Enclosure 2

UUSA Responses to Human Factors Engineering and Environmental RAIs

Figure RAI 1-4-1 provides the logarithmic plot of HF trend data from 21 May 2023 to 11 July 2024 that was captured by the Utility PCS for the following HF monitors from Table RAI 1-4-1:

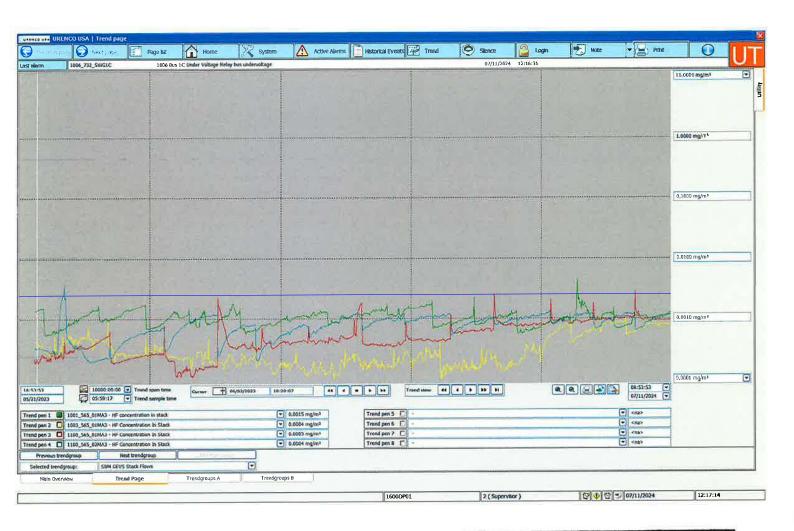
Hydrogen fluoride (HF) emissions are presented as projections and estimates, but it does not appear that actual HF emission data is included for operations to date. To describe potential impacts from emissions associated with the processing U-235 enriched up to 10 wt. %, the NRC staff needs information about current HF emissions.

If HF emissions data is collected, provide HF emissions data for the timeframe since 2015 to confirm the estimates in the 2015 EA (similar to format provided in the "UUSA Occupational TEDE" table). Otherwise, discuss whether the 2015 EA estimates are accurate representations of HF emissions since 2015 and provide a basis.

- 1001-565-1MA3
- 1003-565-1MA3
- 1100-565-1MA3
- 1100-565-2MA3

It is reasonable to expect that similar HF concentrations exist at the other operating GEVS at UUSA.

The solid blue horizontal line in Figure RAI 1-4-1 represents an approximate value of the maximum HF concentration from Table RAI 1-4-2 that results in annual HF emissions at, or below, the projected emissions from the 2015 EA, which assessed emissions from an in-service 10 MSWU facility, considering operation of the yet-to-be constructed and operated SBM-1007 and SBM-1009.

It is reasonable to conclude that by making conservative assumptions about the operating GEVS at UUSA regarding volumetric flowrate, continuous operation, normal operating parameters and a limited data set, that the projected HF emissions considered in the 2015 Environmental Assessment for facility expansion remain bounded by assessed current and future operation at the UUSA facility.
